# The Northgate Pedestrian/Bike Bridge

Will the Northgate Ped/Bike be a "Bridge of Dreams"?

Submitted to City of  
Seattle June, 2014

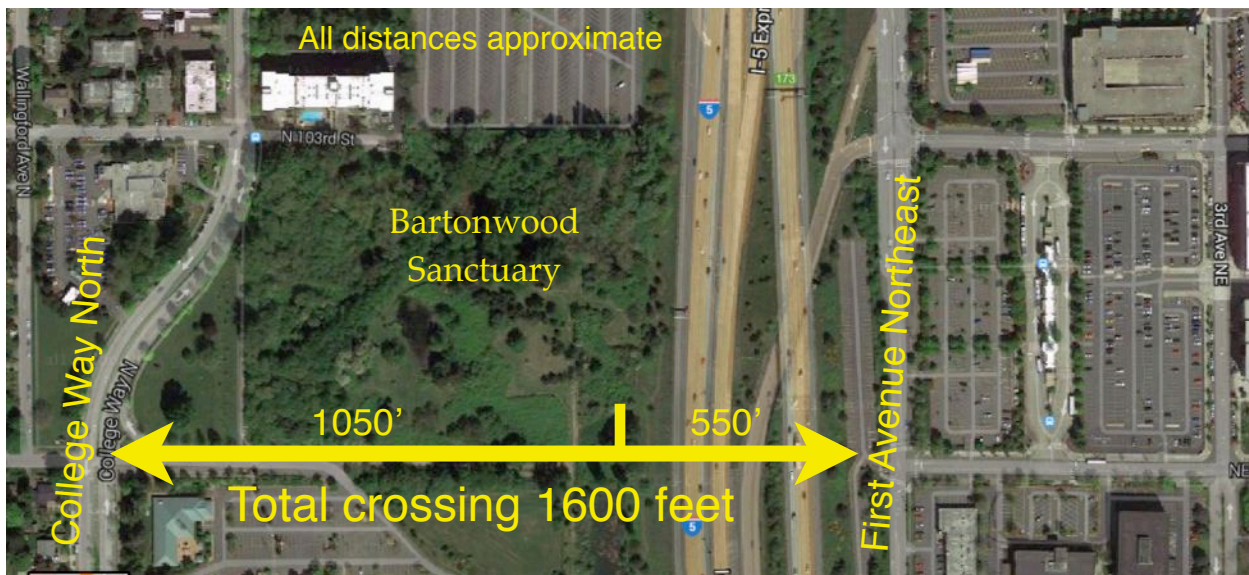
I hope they can do so but the issues are substantial. Consider the distances.

Crossing I-5, First Avenue NE to W side I-5 — about 550 feet.

Crossing Bartonwood Sanctuary, west side of I-5 to College Way N — about 1050 feet. Total about 1600 feet. That's about 7 city blocks, a good walk.

There is limited or no natural surveillance.
